**Consumers
Power
Company**

April 17, 1985

DOCKET 50-255 - LICENSE DPR-20 - PALISADES PLANT -
UPDATE OF INSERVICE PUMP TESTING PROGRAM
CORRECTED INFORMATION

Service Water System--Diff. Pressure vs Inlet Temperature with Two Pumps Operating. Expected values, Alert Limit and Required Action Limit MO-16

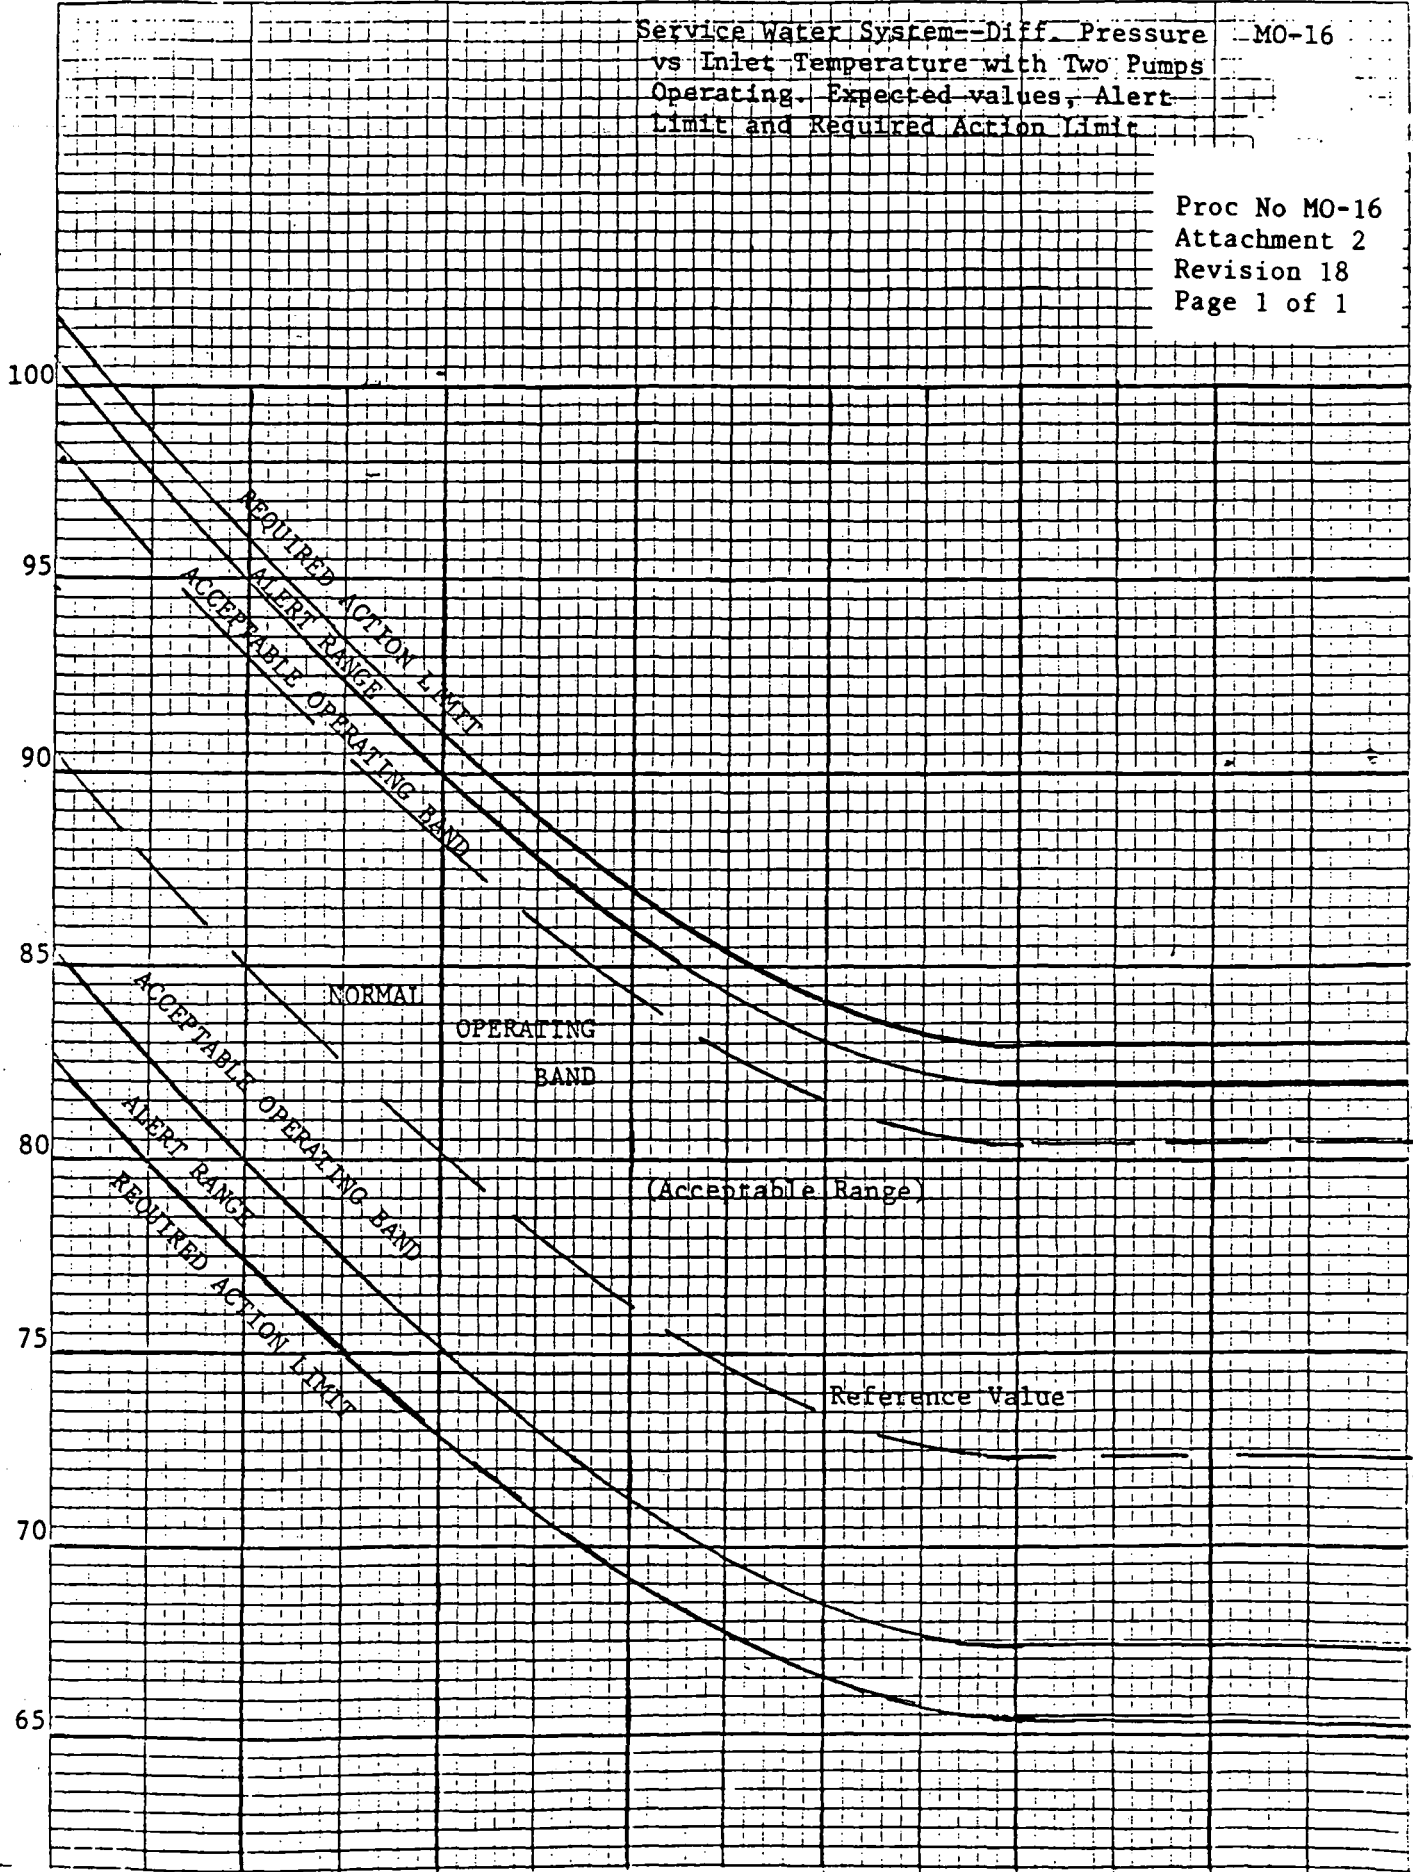
Consumers Power Company letter dated October 27, 1981 and entitled "Update of Inservice Pump Testing Program" contained a graph titled "Service Water System Diff. Pressure vs. Inlet Temperature with Two Pumps Operating. Expected Valves, Alert Limit and Required Action Limit." This graph was identified as being outdated because of different graphs in the surveillance test procedure and the basis document by IE Inspection Report 050/255-83-16 Open Item 255/83-16-05. This item was closed by IE Inspection Report 050/255-84-04 since the surveillance procedure and basis document were made to conform after review of the graphs. The final close out of this issue is to update our October 27, 1981 submittal. Attached, is the updated graph which we are submitting as a correction to our October 27, 1981 letter.
